**GENOA CHARTER TOWNSHIP BOARD**

**May 16, 2016  
Regular Meeting  
6:30 p.m.**

**Re: Lakeshore Village Apartments Phase 3 – Revised Traffic Impact Study Review**

| <b>Subject:</b>   | Lakeshore Village – Site Plan Review #2                                    |

SCALE: 1" = 60'  
 JOB NO. 16-010  
 DATE: 2-3-2016  
 SHEET NO. C6

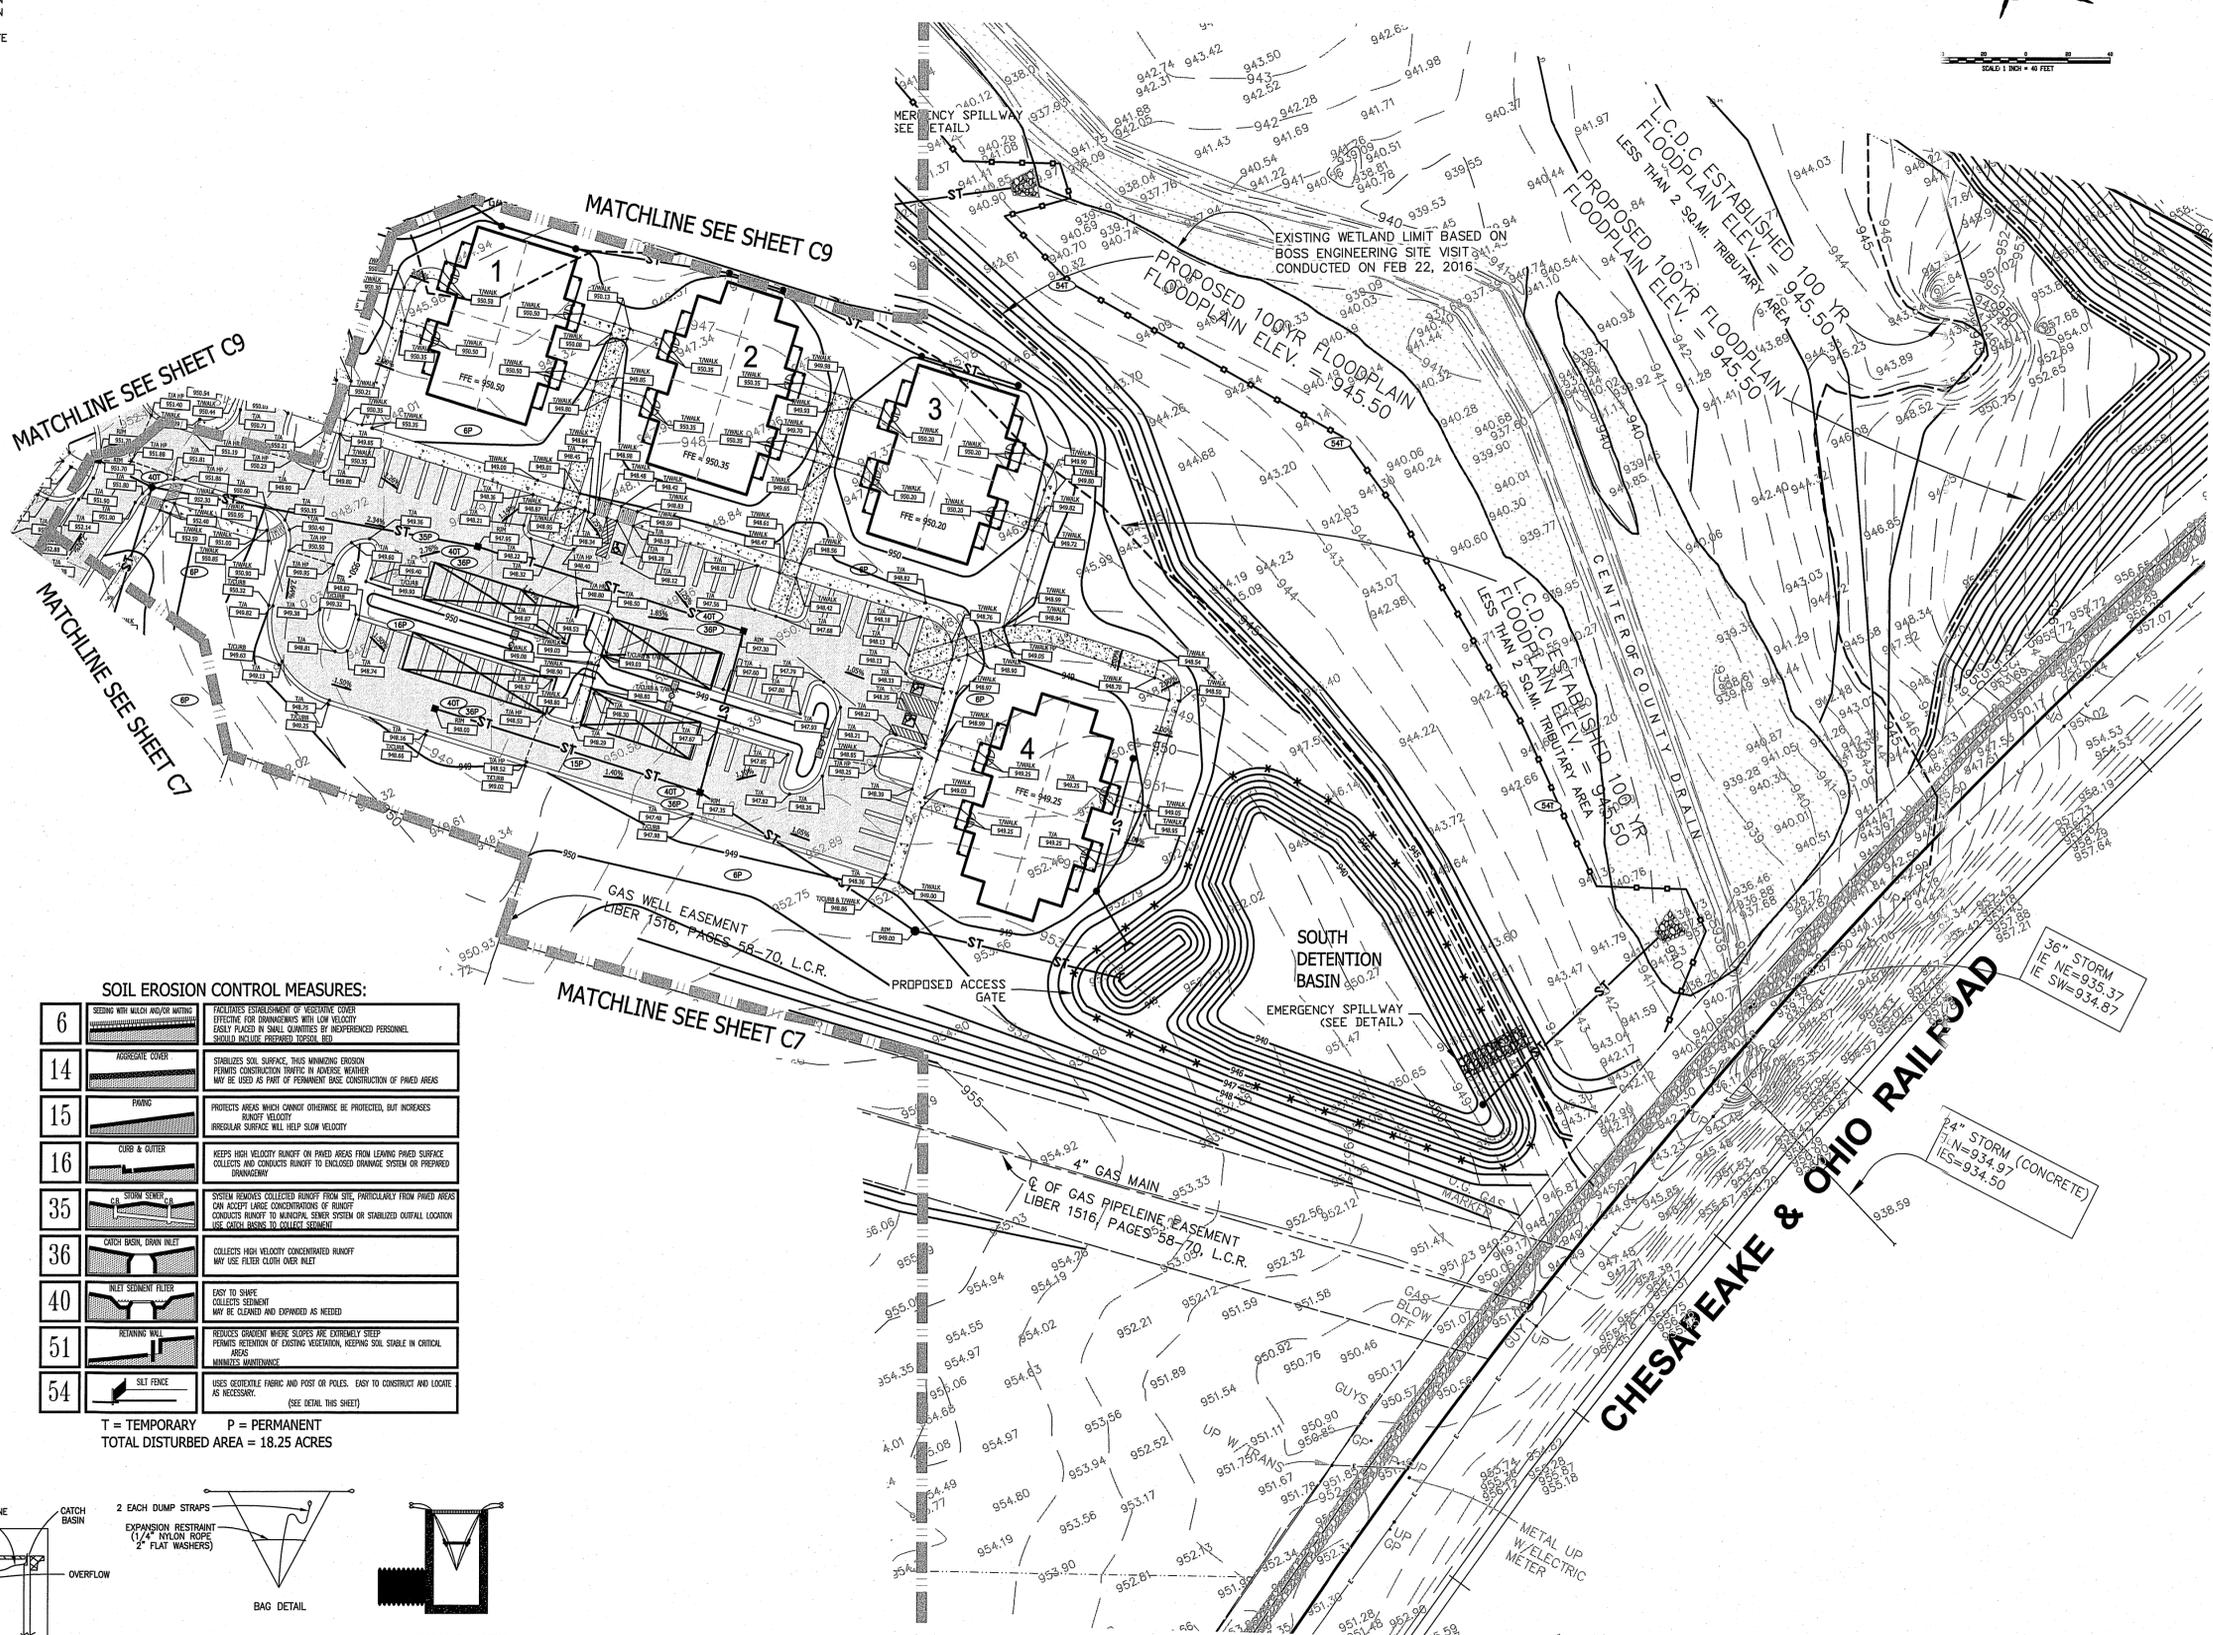
- c.) Proposed walk grades should be shown on west side of the north-south access drive on Sheet C7.
- 8.) Miscellaneous – The project heading shown on Sheet C1 should reference the Southeast 1/4 of Section 6, rather than Section 8.
